DS #: 4615

PROJECT: NORTH CREEK (PREVIOUSLY SABLE CREEK)
(PROJECT IN CLARK COUNTY FOR CLV CONCURRENCE)

CITY OF LAS VEGAS		DATE:
INTER-OFFICE MEMORANDUM		July 16, 2014
TO: Land Development Services Department of Building and Safety		FROM: Albert Sung, P.E. Flood Control Project Engineer Department of Public Works
SUBJECT: Drainage Study for: North Creek (Previously a portion of Sable Creek) (Project in Clark County for CLV Concurrence)		COPIES TO: Slater Hanifan Group
Cross Streets:	SWC of Farm & Grand Canyon	Lennar Homes
File Number:	F:\Depot\DSMemos\DS4615D.doc	Bart Anderson, P.E., DevCo
Parcel Number:	125-18-301-025	Doug Rankin, Planning
Zoning Action:	ANX-49991	
FEMA Flood Zone	YES NO X	
Proposed Storm Drain	YES X NO

UPDATE No.4 TO THE TECHNICAL DRAINAGE STUDY

EXHIBIT F
SHEET 1 OF 1
ADD1 UPDATE NO. 2

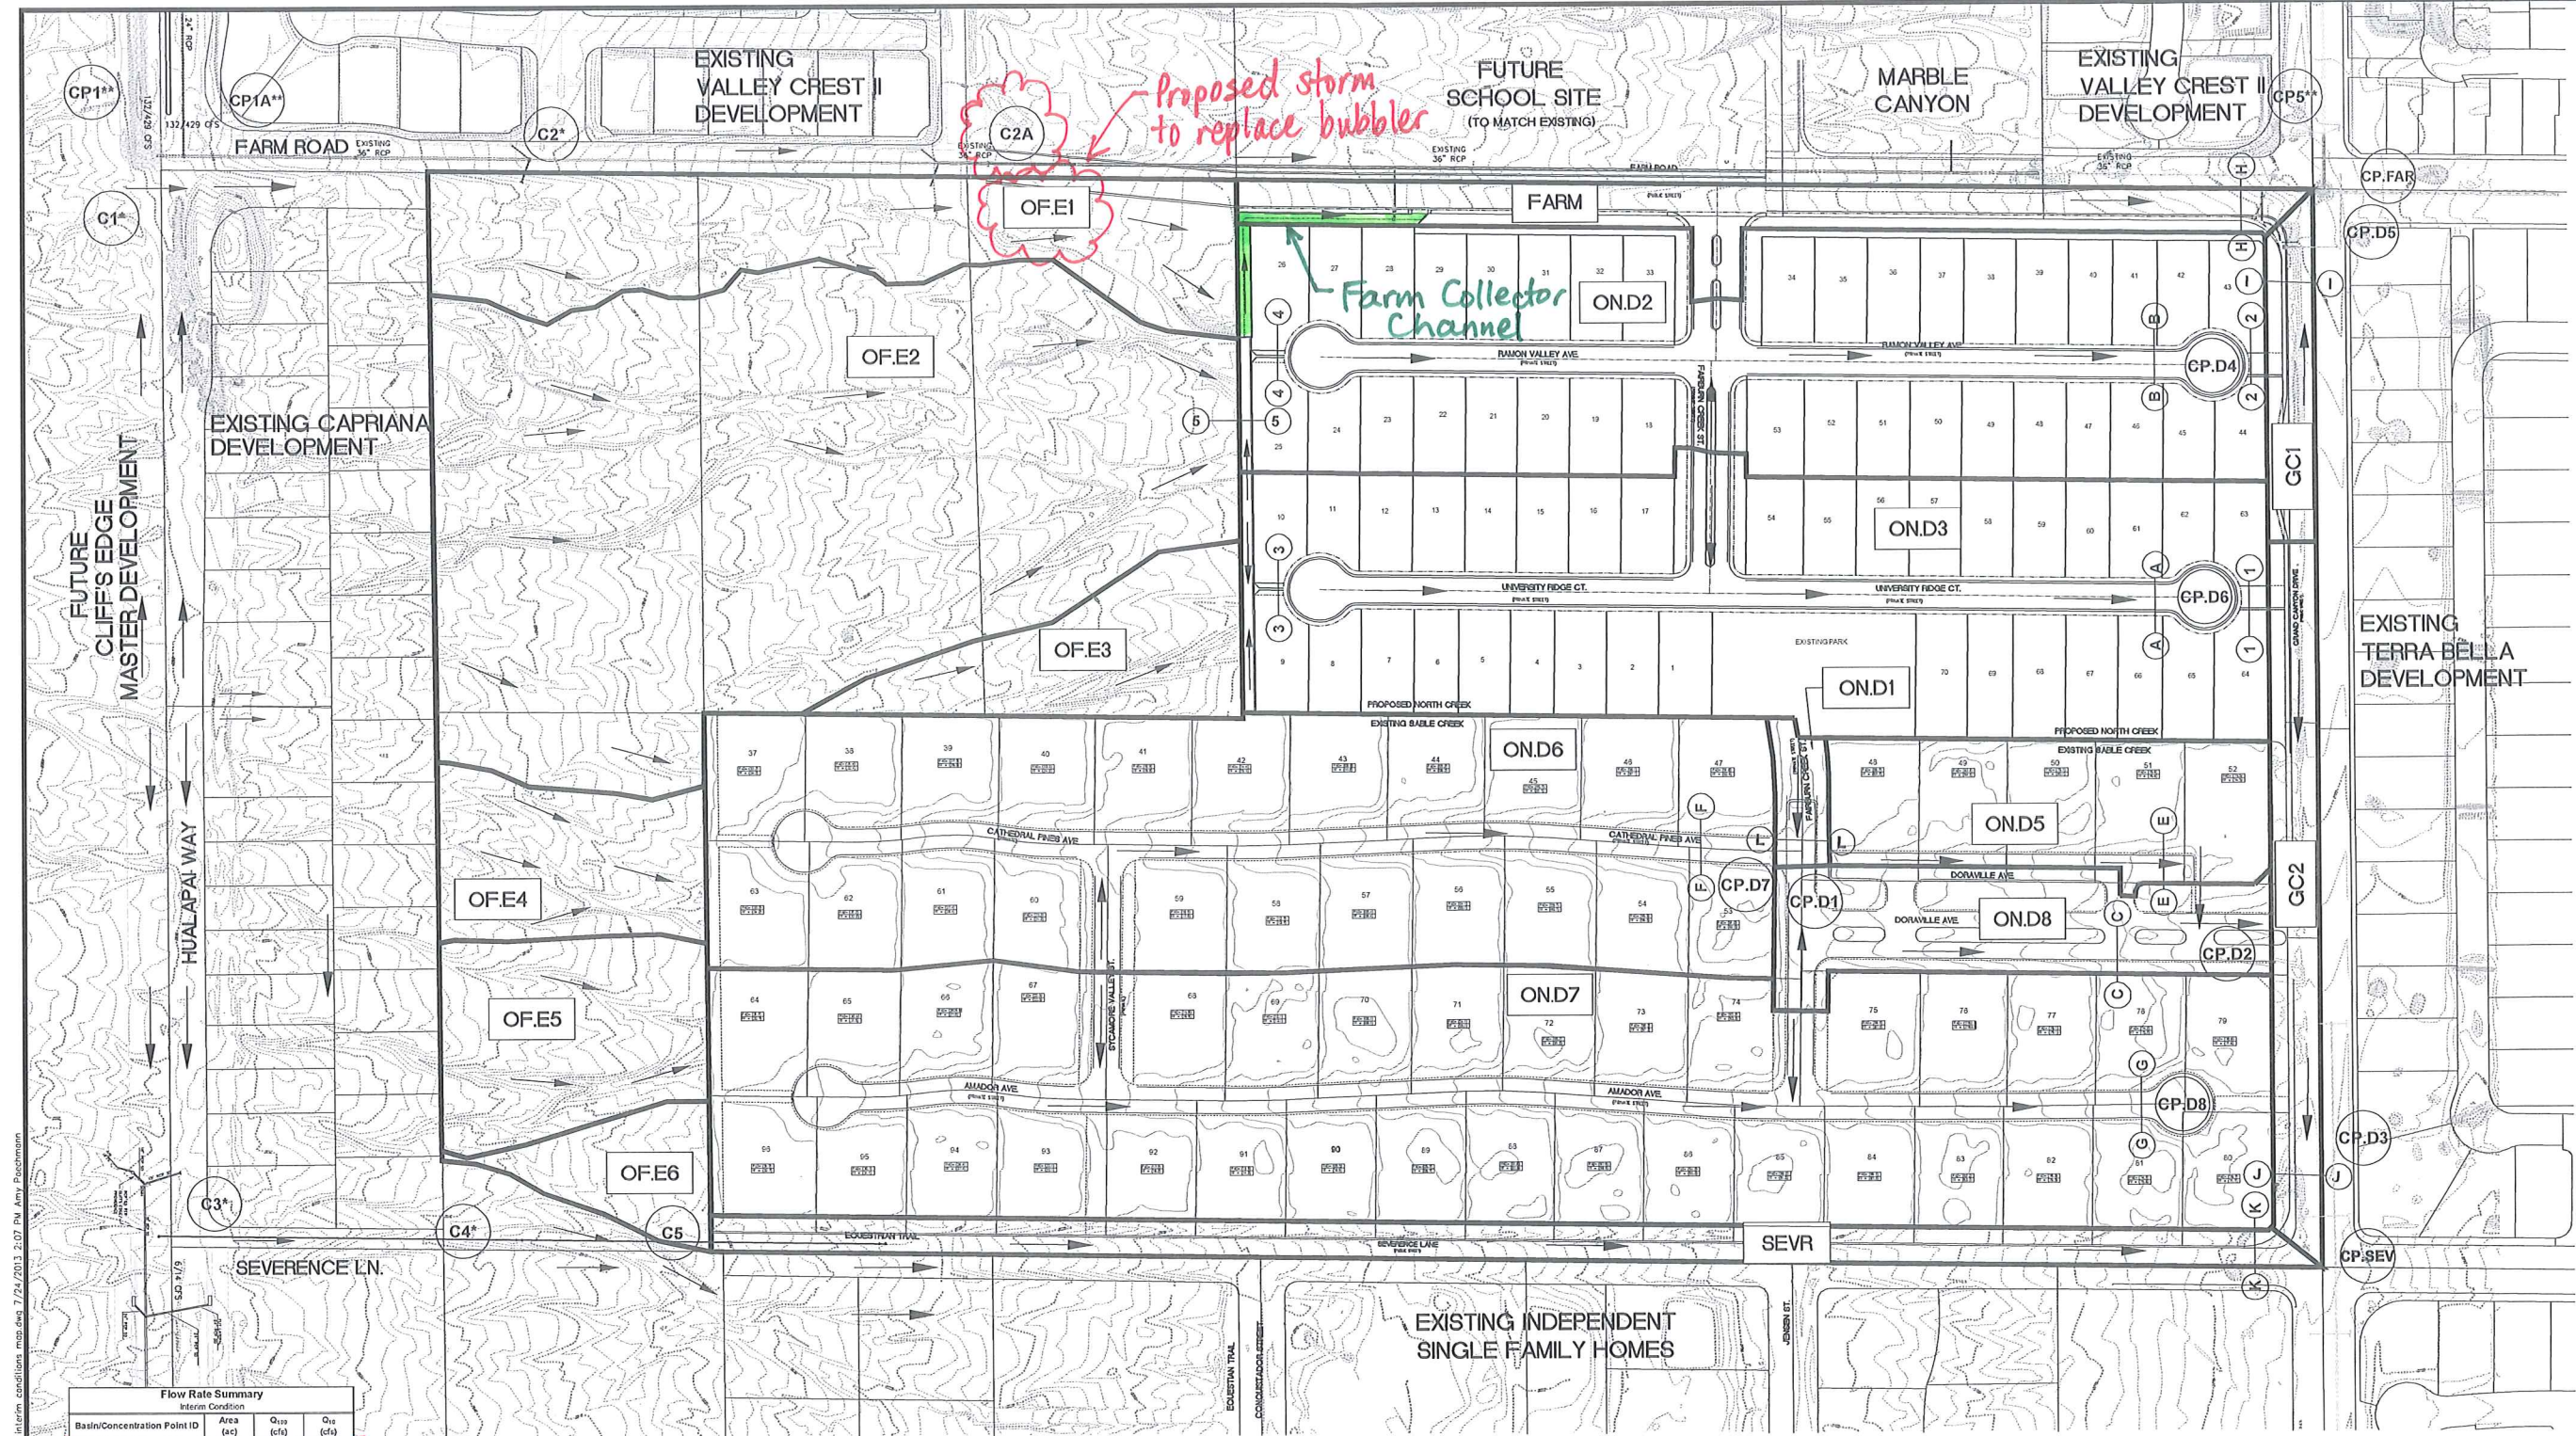
7. **Comment:** *It is noted that the flow arrows for Basin OFE1 on Exhibit F should be pointing north to Farm Road.*

Response: The flow arrows on Exhibit F are correct as shown. Basin OF.E1 does not naturally flow to Farm Road, rather the basin drains to a lowpoint located approximately 200 feet south of the Farm Road centerline. The proposed Farm Road Collector channel intercepts flow from the lowpoint and conveys the storm flow back to Farm Road.

Revised Drainage Exhibit

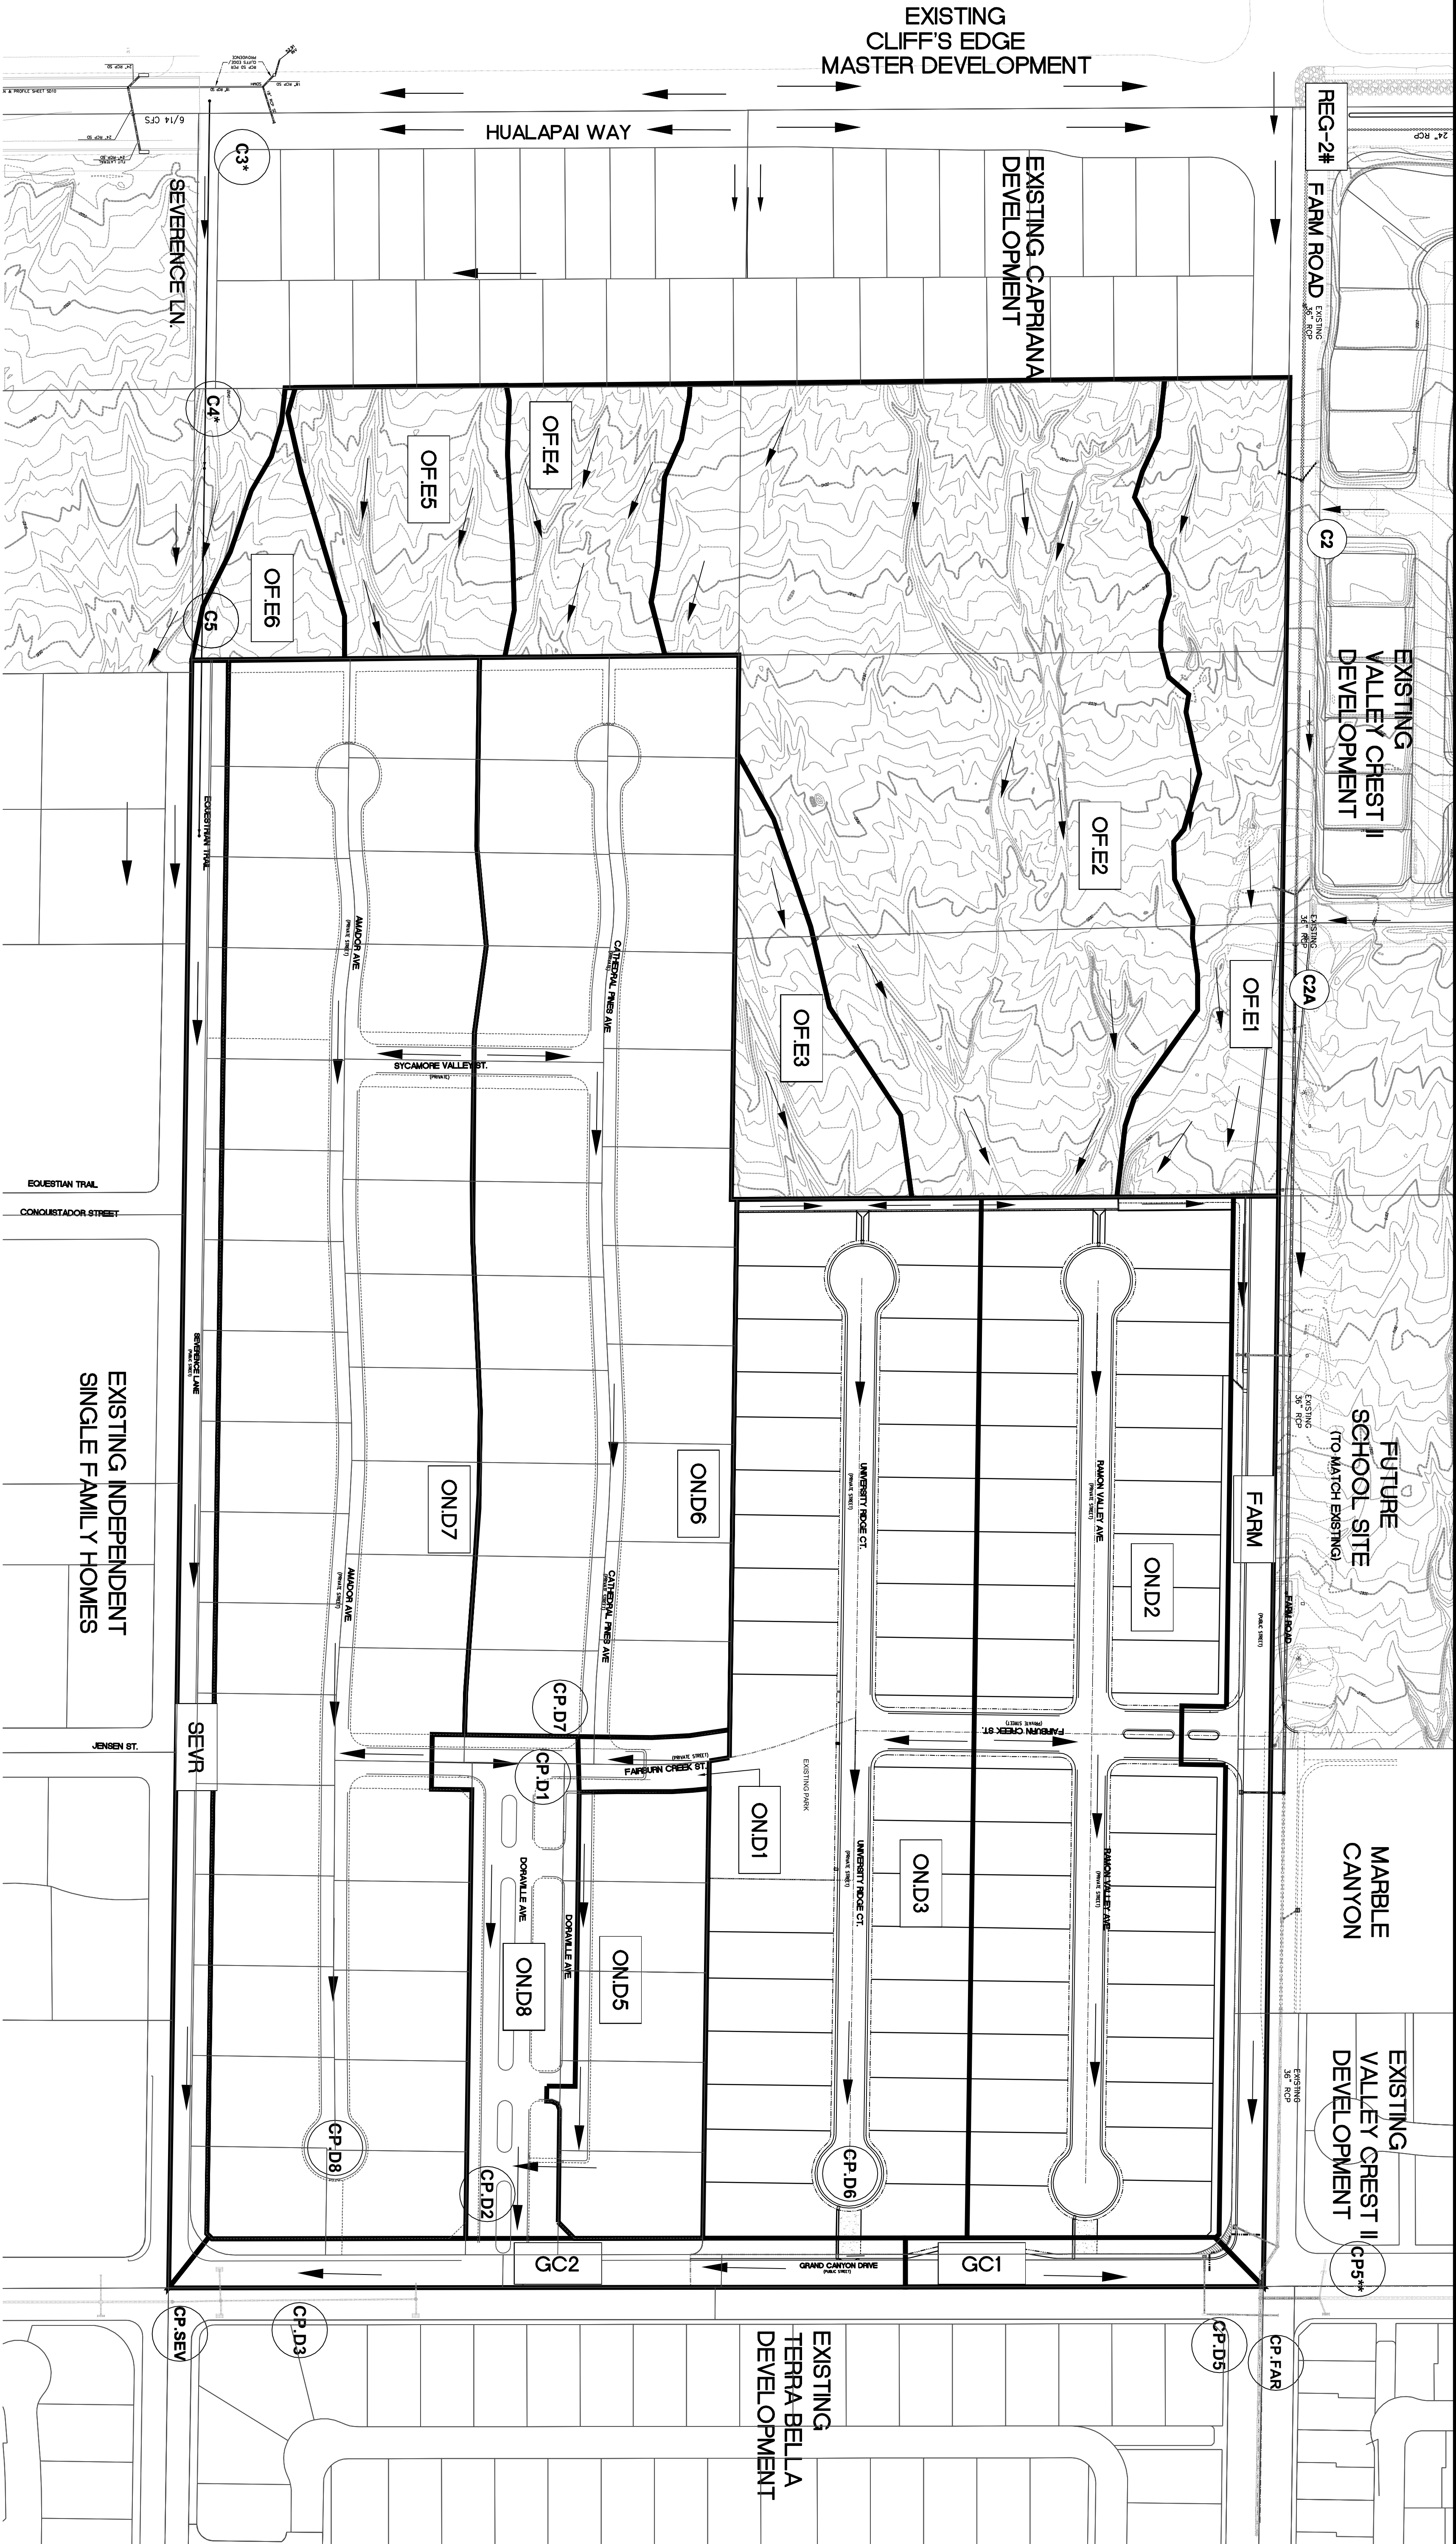
REVISED INTERIM CONDITION IS PRESENTED WITH UPDATE NO. 4 FOR THE PURPOSE OF ESTABLISHING A REDUCED FLOW RATE IN THE FARM COLLECTOR BASED ON THE ASSUMPTIONS THAT THE UPSTREAM OFFSITE BASINS ARE NOW IN ESSENTIALLY THEIR ULTIMATE CONDITIONS AND THAT THE 36-INCH STORM DRAIN IN FARM ROAD IS CONTINUOUS.

Refer to Exhibit F3, included in Appendix B, for a detailed illustration of the revised interim condition presented with this submittal. Note that not only the flow rate for the Farm collector channel is being revised with this update and that therefore, only information relevant to the Farm collector channel flow rate is provided on the exhibit. Refer to reference material for complete hydrologic information.
